SERVICE BULLETIN

PURPOSE : CORRECTION	ISSUE NO. : MSB-11E22-504	DATE : 2011-09-20
SUBJECT : DRAIN PLUGS FOR TC-SST		<MODEL> <M/Y>
GROUP : TWIN CLUTCH-SPORT SHIFT TRANSMISSION (TC-SST)		(EUR/RUSSIA/ UK(Japanese Domestic Spec.)) See following 2. Applicable Manuals table.

The number of drain plugs for TC-SST is changed from three to two for better serviceability. In addition, there has been an incorrect instruction (illustration) regarding the drain plugs. This Service Bulletin contains the correct information regarding the above change and correction.

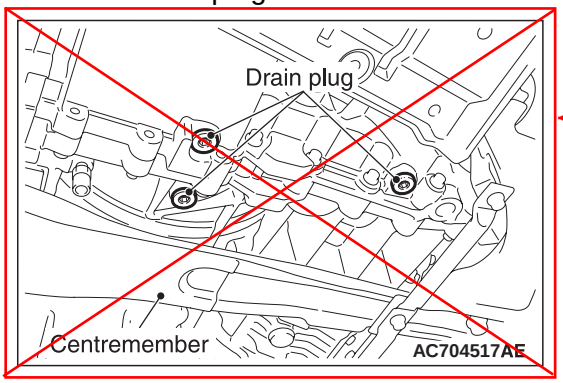
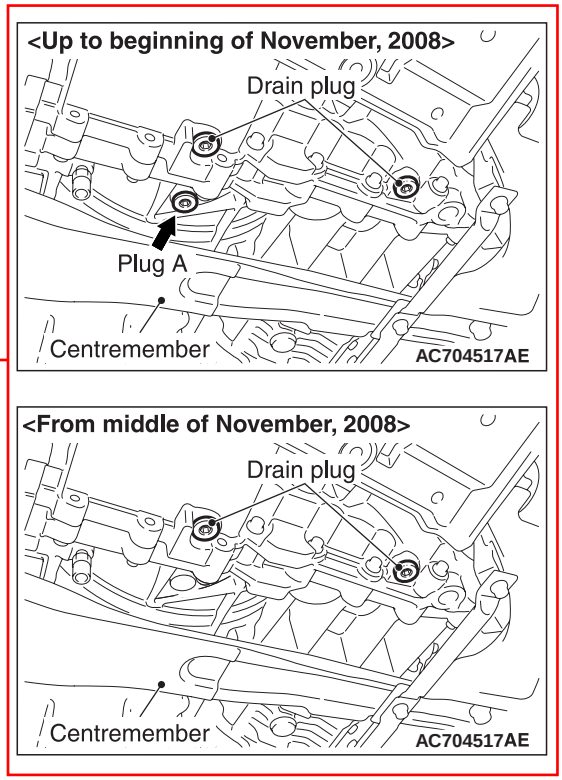
7. Remove the drain plugs, and leave it for 3 minutes to drain the fluid.

NOTE: Do not remove this plug when the TC-SST with plug A is received the maintenance. If this plug is removed by a mistake, install it by the same procedures as for the drain plug.

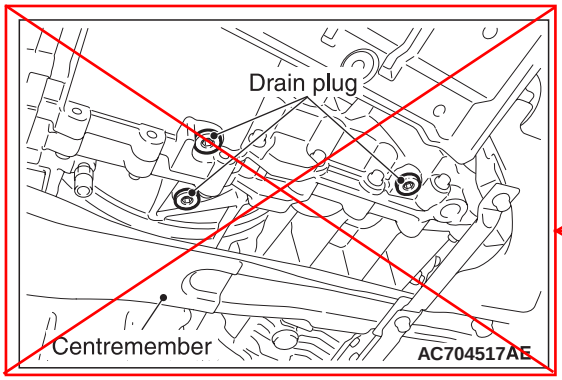
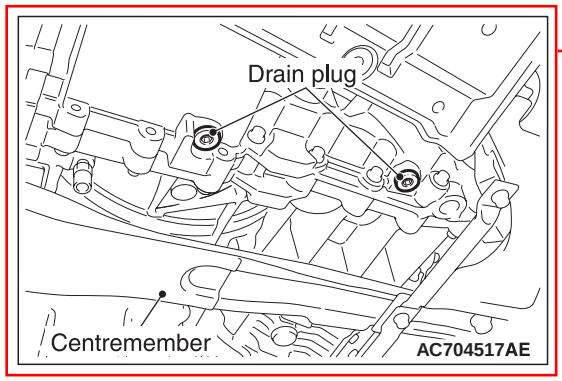
7. Remove the drain plugs, and leave it for 3 minutes to drain the fluid.

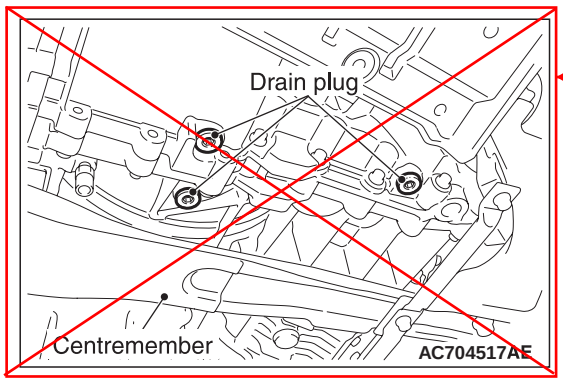
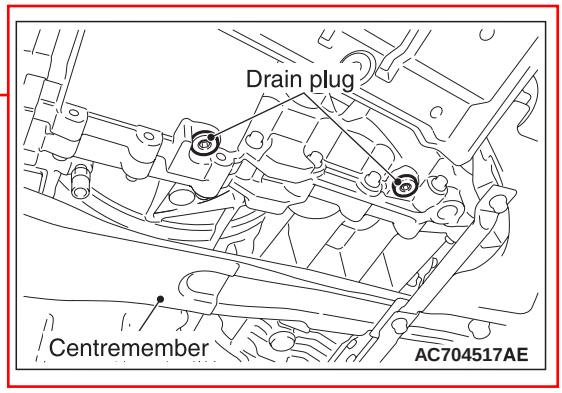
7. Remove the drain plugs, and leave it for 3 minutes to drain the fluid.
